# **Characterization Report Feature F-33, Former Large Motor Washout Area Lockheed Martin Corporation, Beaumont Site 1 Beaumont, California**

Subject: Submittal of Final *"Remedial Design Characterization Report, Feature F-33, Former Large Motor Washout Area, Beaumont Site 1, Beaumont California"*

**RESPONSES TO DTSC COMMENTS ON THE CHARACTERIZATION REPORT FEATURE F-33,  
FORMER LARGE MOTOR WASHOUT AREA, LOCKHEED MARTIN BEAUMONT SITE 1  
BEAUMONT, CALIFORNIA, SUBMITTED APRIL 2009  
TETRA TECH, INC**

**DTSC COMMENTS OF JUNE 10, 2009**

**Figure 3-2**  
**Idealized Geologic Cross**  
**Section A-A' and B-B' at**  
**Feature F-33**

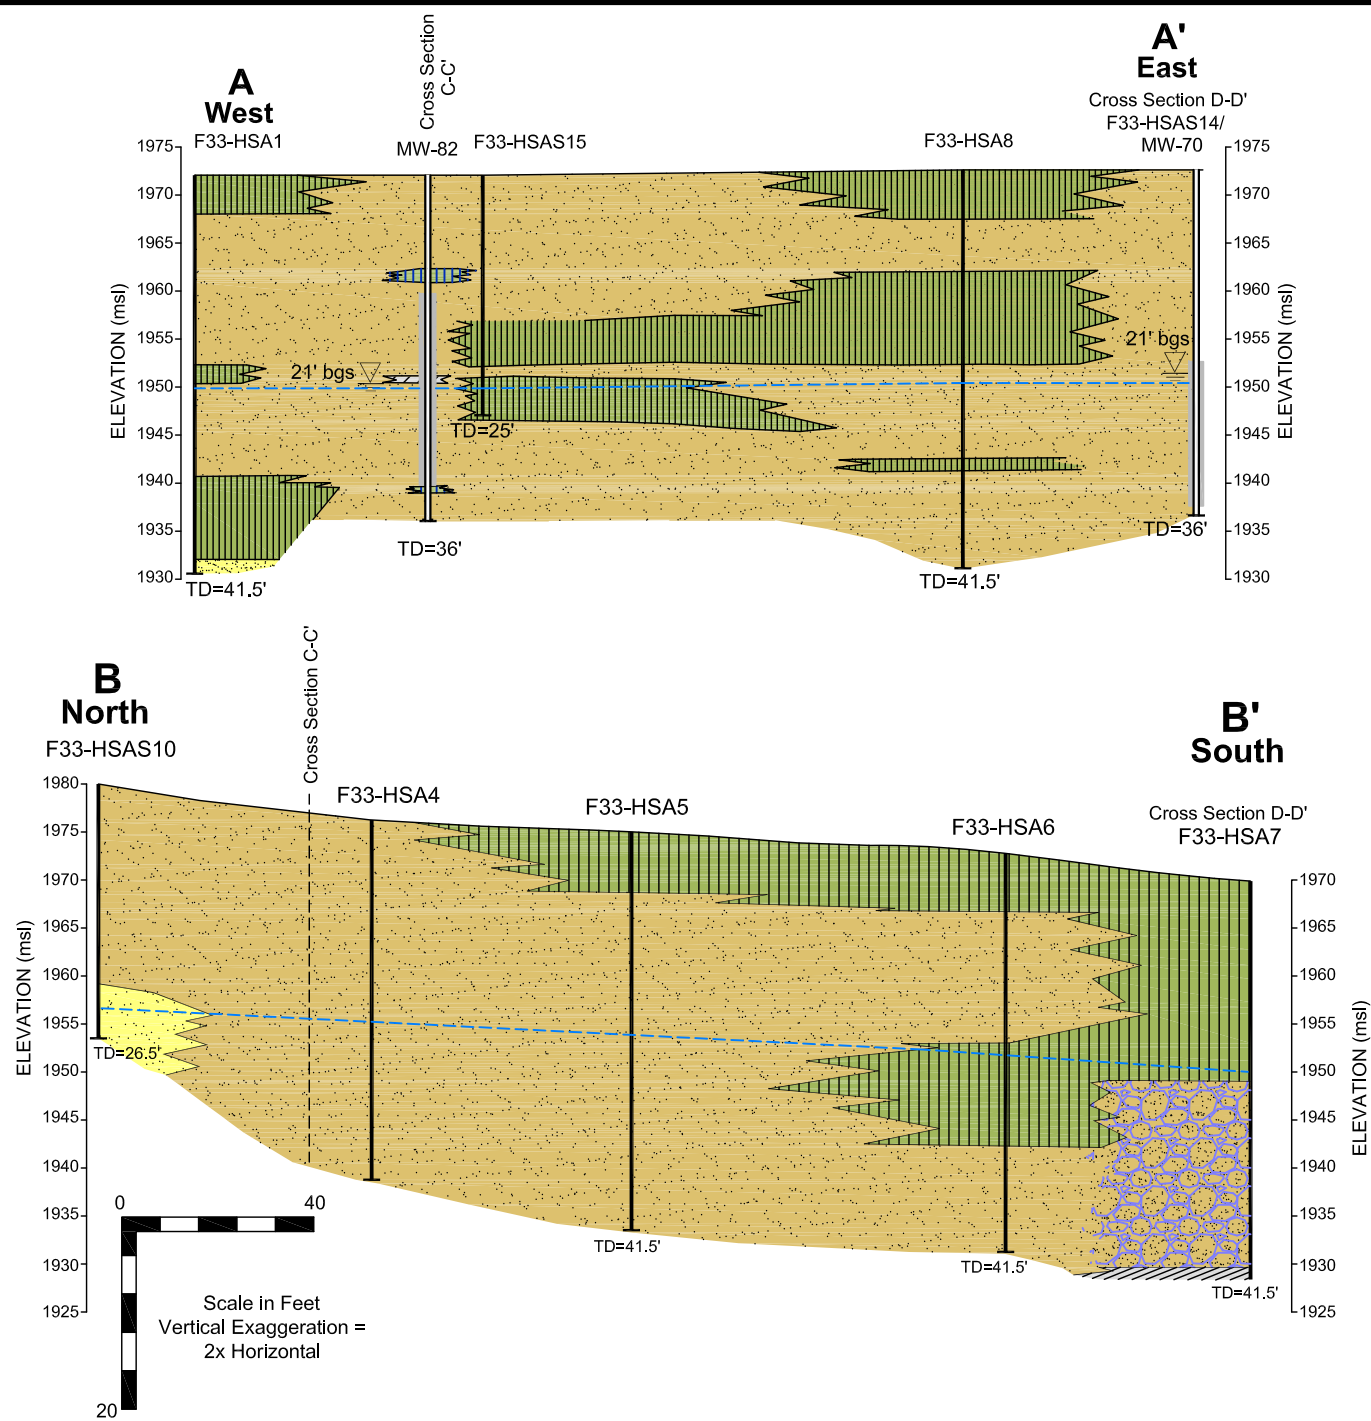
Specific Comments		
Comment	Response	Proposed Action
1. Figure 3-2: An approximate groundwater elevation should be included on this figure. Also, intersections of D-D' should be added to both cross-sections.	An approximate groundwater elevation has been added to Cross-Sections A-A' and B-B'. In addition, the intersection of D-D' will be identified on both sections A-A' and B-B'.	Add the changes requested by the reviewer.
2. Figure 3-3: The intersection of MW-82 and Cross-section A-A' should be added to Cross-Section C-C'	A note has been added to cross-section C-C' that shows where Cross-Section A-A' intersects this section at MW-82.	Add the changes requested by the reviewer.
